CHECKING  
FUEL-INJECTION PUMPS

Workshop: EP  
08.1997  
ST 0568 De

PES 4 M ..RS 185  
G 400 074 883

### Modification of idle leaf spring

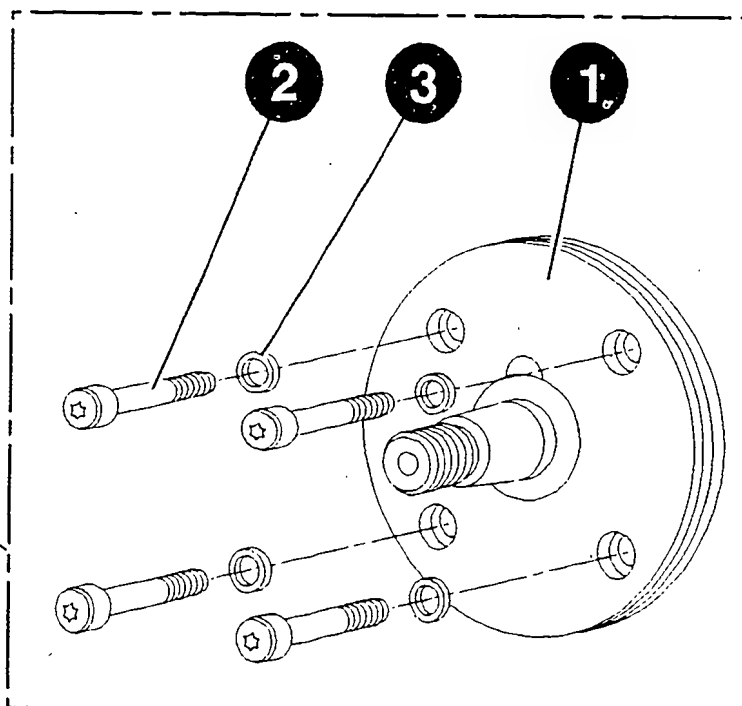
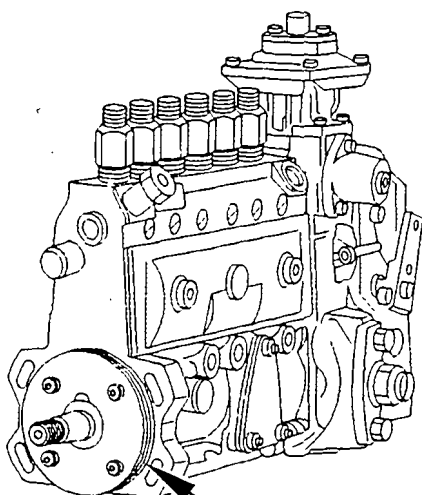
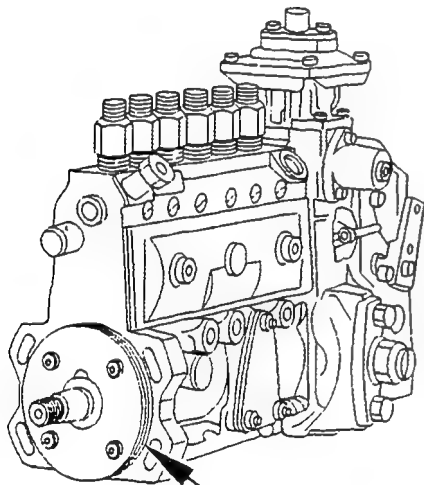
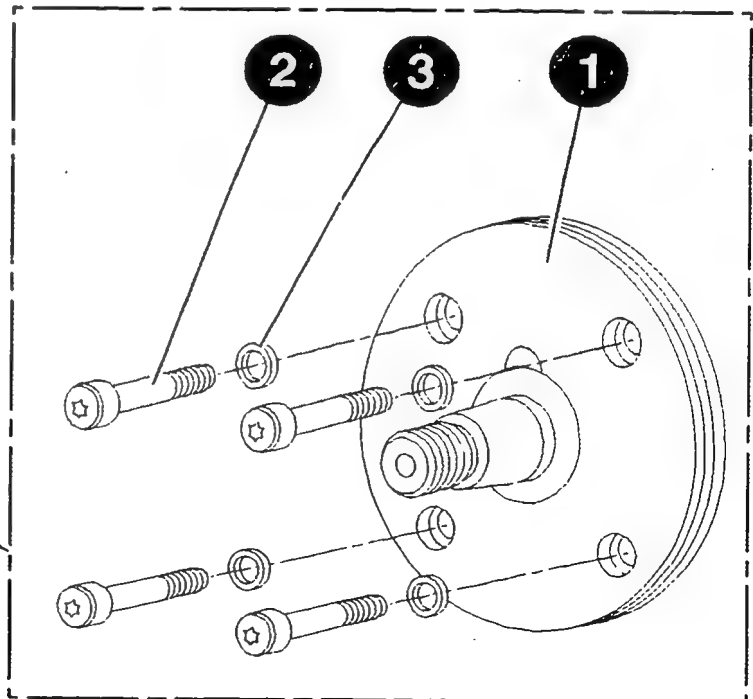
Cummins Engine Co. has issued Temporary Repair Practice / Field Campaign to correct loosened bearing end plate bolts on the subject Fuel Injection Pump installed in Samsung excavator.

Affected Engine Serial Numbers are:  
for the TPR 21155012 to 21249143 and  
for the FC 21168445 to 21240594.  
Both the TPR and the FC require  
modifications to vehicle and engine.  
Without these modifications the repair  
you perform may be ineffective and the  
bearing end plate may loosen again.

1. On FIP without any damage, using standard Bosch repair procedures, replace the current bearing end plate with the new version PN F 002 A11 208 (Pos. 1).

Discard the old screws and replace with new low head Torx screws M6 x 18 mm grade 10.9, PN 2 912 742 199 (Pos. 2).

Clean the screw bores in the FIP housing, install the screws and steel spacers PN 1 410 100 037 (Pos. 3) with Loctite 270 following manufacturers recommendations and torque to 10 +1 Nm, loosen and retorque again to 10 +1 Nm. Refer to the parts list for all other parts and gaskets necessary.

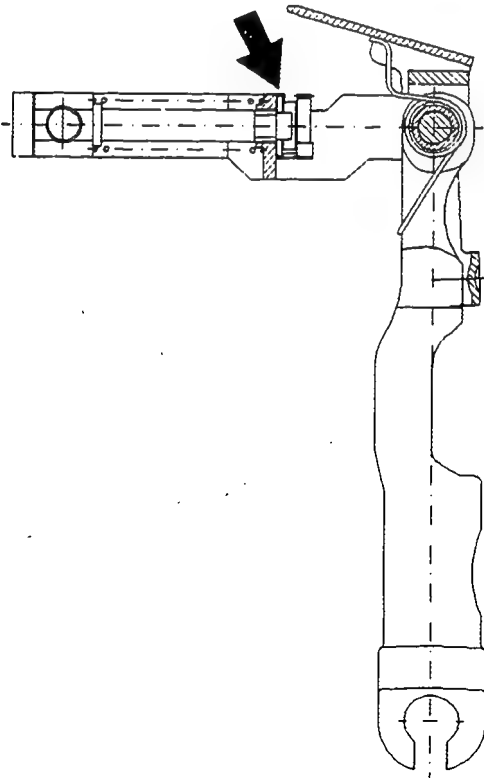
This is due to a sticking lock washer in the link fork of the governor (Fig., arrow).

Screw out large screw plug in governor cover (item 1). Fully deflect control lever and actuate shutoff lever at the same time. A visual inspection through the open hole in the governor cover makes it possible to determine whether or not the lock washer in the link fork of the governor is sticking.

If it is, detach entire pump assembly from engine and, following removal, replace fulcrum-lever unit (item 2) with a new one.

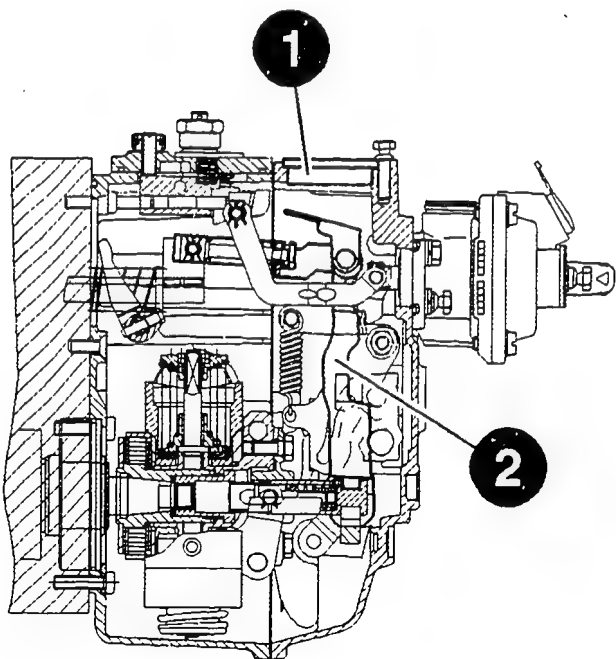
Check freedom of movement of lock washer before installing new fulcrum-lever unit.

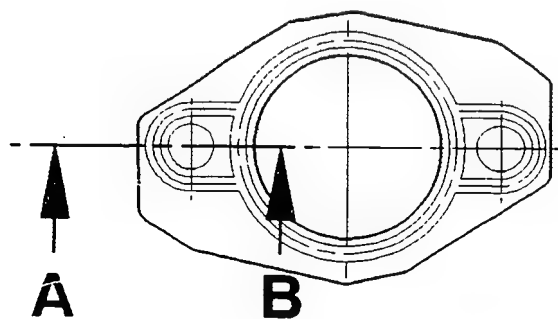
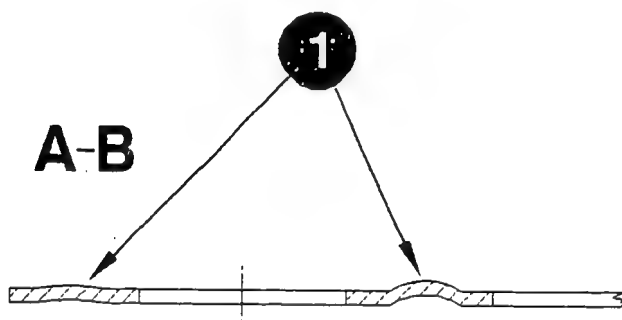
Curved sealing surface must face  
inwards (timing-device hole).

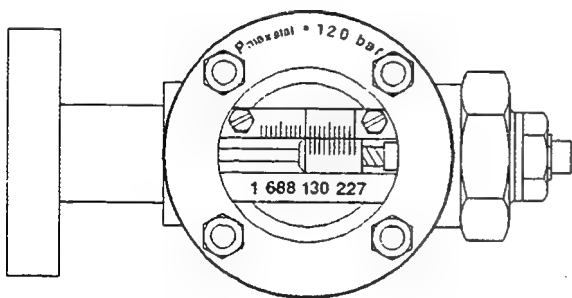
FOR SAFETY REASONS (DESTRUCTION OF VIEWING PORT), PREVIOUS MEASURING TOOL (1 688 130 139) IS NOT TO BE USED FOR TESTING L2 VE PUMPS.

FOR CHECKING HEAVY-DUTY VE PUMPS (L2), EXCLUSIVE USE IS TO BE MADE OF THE NEW TIMING-DEVICE TRAVEL MEASURING TOOL, PART NO. 1 688 130 227.

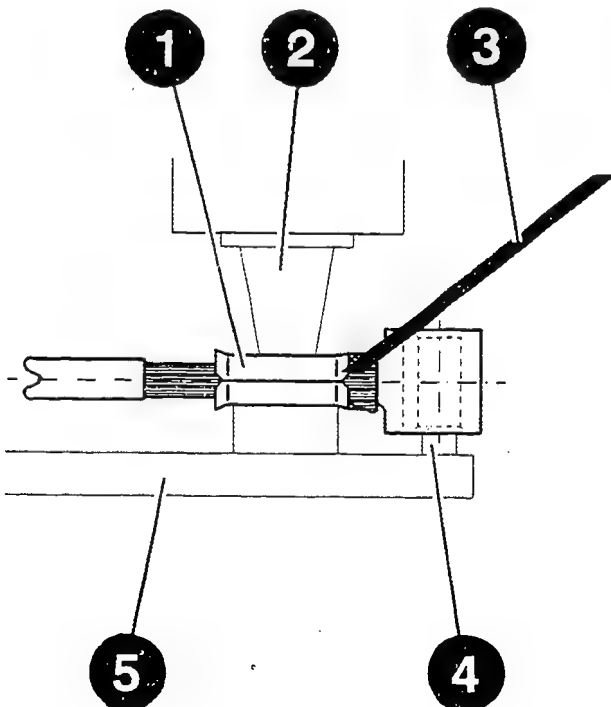
Perform soldering work with extreme care. Thoroughly clean soldered joints (crimp and wire bundle) with acetone. Only solder on soldering tag side, not over entire crimp length (so as not to impair flexibility of wiring). Apply soldering iron to side of crimp (Fig.) and only heat to the extent required to cause solder to flow into wire bundle.

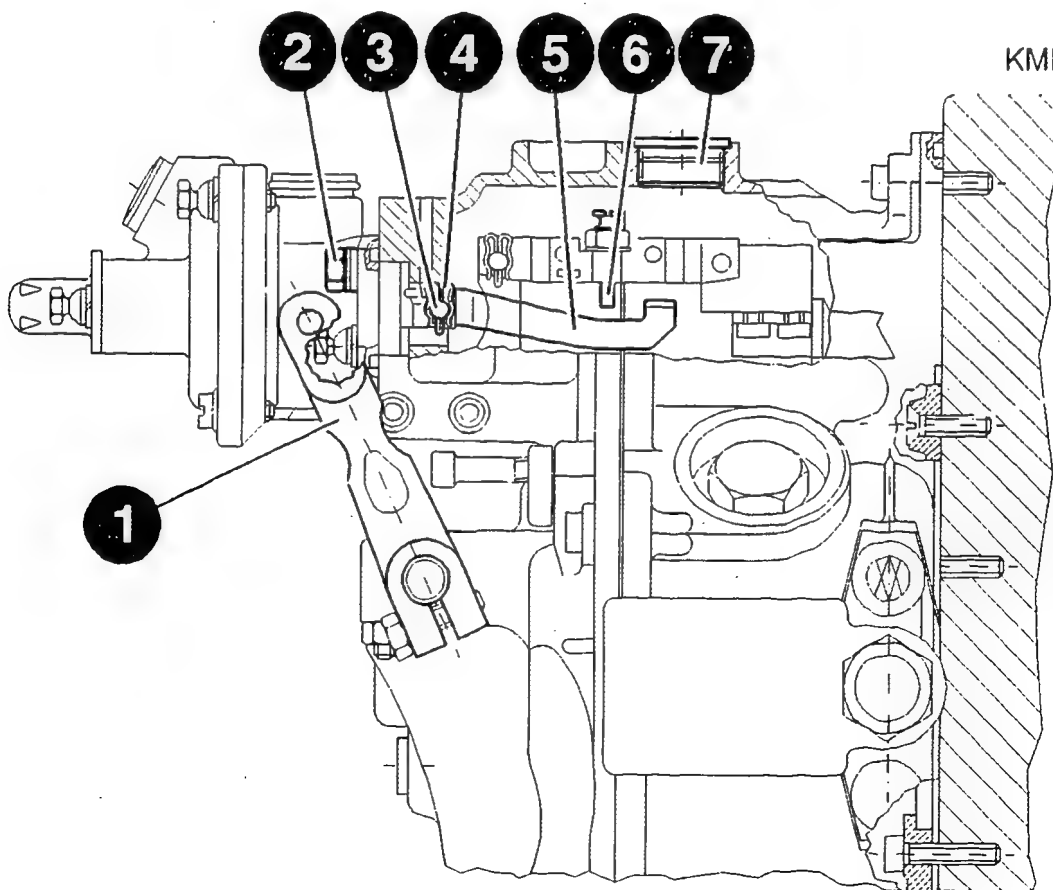
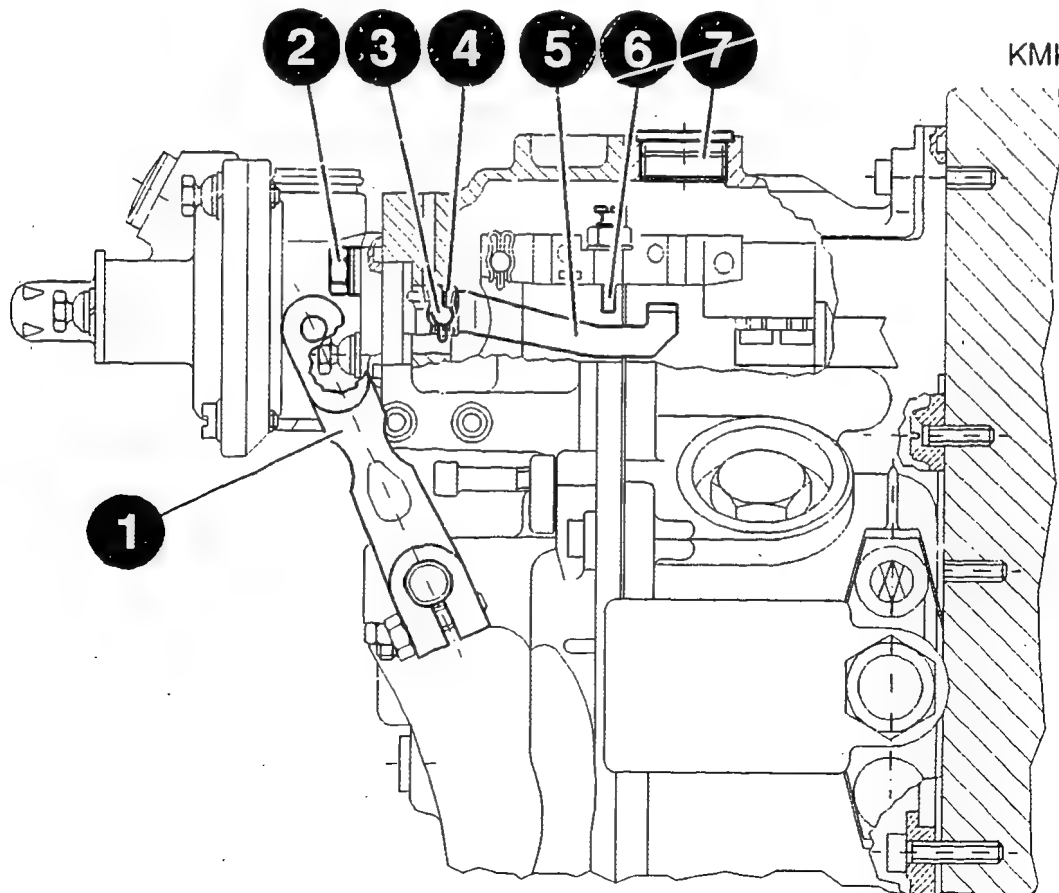
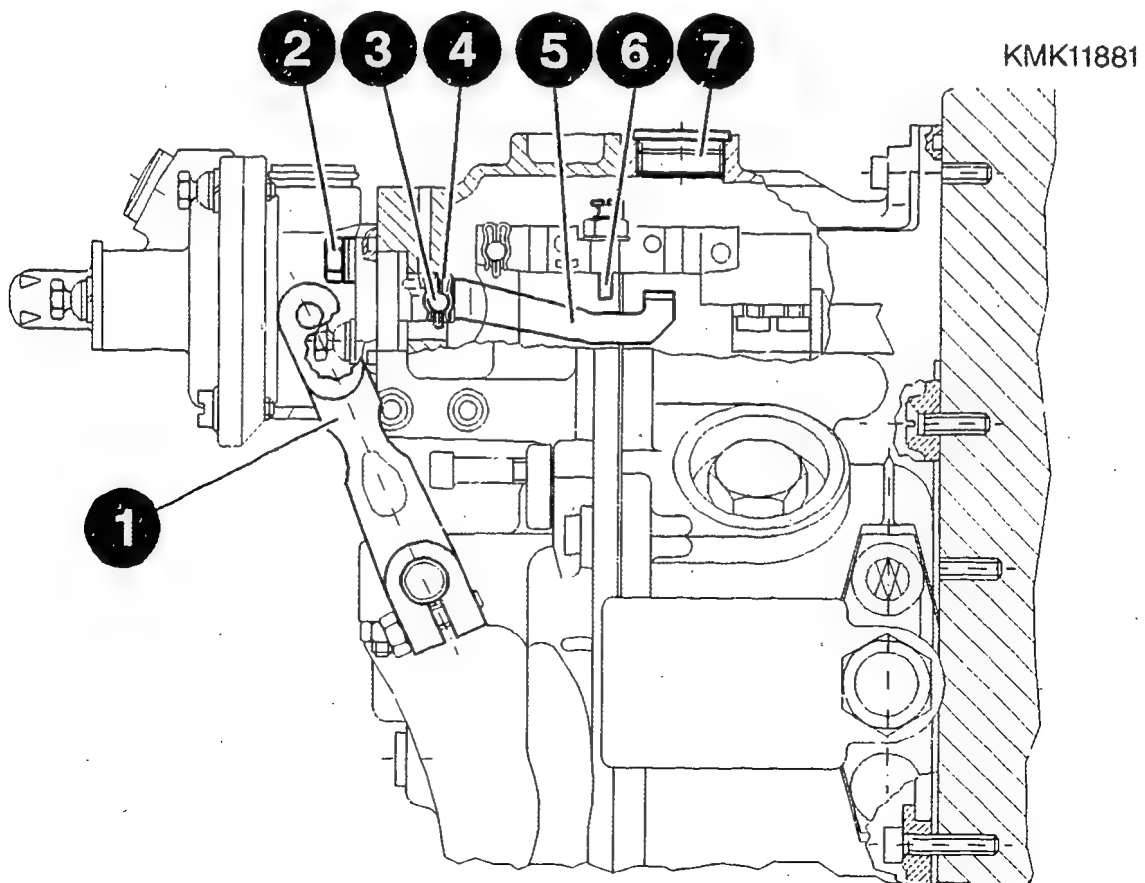
- \* Replacement of plate
  - Pull off locking spring (4).
  - Remove LDA plate (5) from lifting rod.
  - Attach new LDA plate (5).
  - Fit new locking spring (4).
- \* Attachment of LDA
  - Move control lever (1) to shutoff position.
  - Turn LDA with LDA plate (5) counter-clockwise through 90 (as viewed from governor end) and insert carefully into top opening in governor cover.
  - Bypass stop pin (6), turn LDA (clockwise) to normal position and guide in last 10 mm.
  - Tighten LDA bolt (2) slightly.

LDA plate (5) is swivel mounted in LDA housing. Incorrect procedure can cause it to become twisted and lead to setting problems/excessive quantity scatter.

Correct installation position of LDA plate is to be checked through top adjustment opening (7) in governor housing/cover.

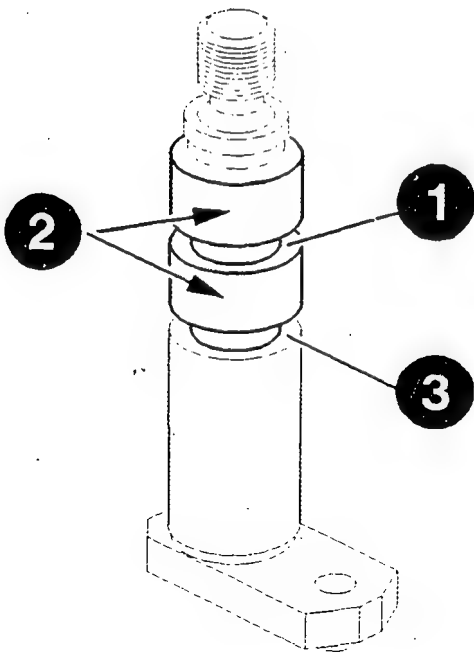
The problem arises from a lack of  
grease in the O-ring groove and the  
area between the O-rings.

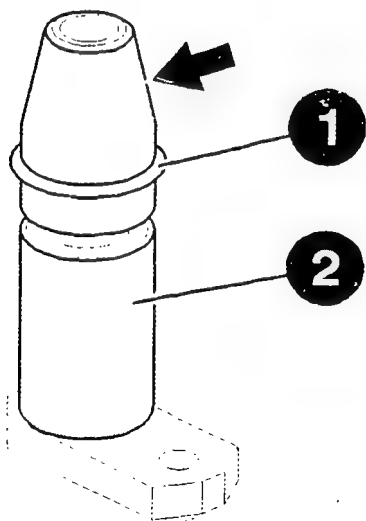
Fill lower O-ring groove with Molycote.  
To protect O-ring, mount assembly  
sleeve 0 986 611 291 KDEP 2937 (arrow)  
on control lever shaft.

Slip on lower O-ring until it engages in groove (in grease).  
Remove adhesive tape.  
Fill upper O-ring groove with Molycote.  
Fit O-ring (O-ring must engage in grease).  
Grease control lever shaft all round with Molycote between O-rings.  
Install control lever shaft in bushing.
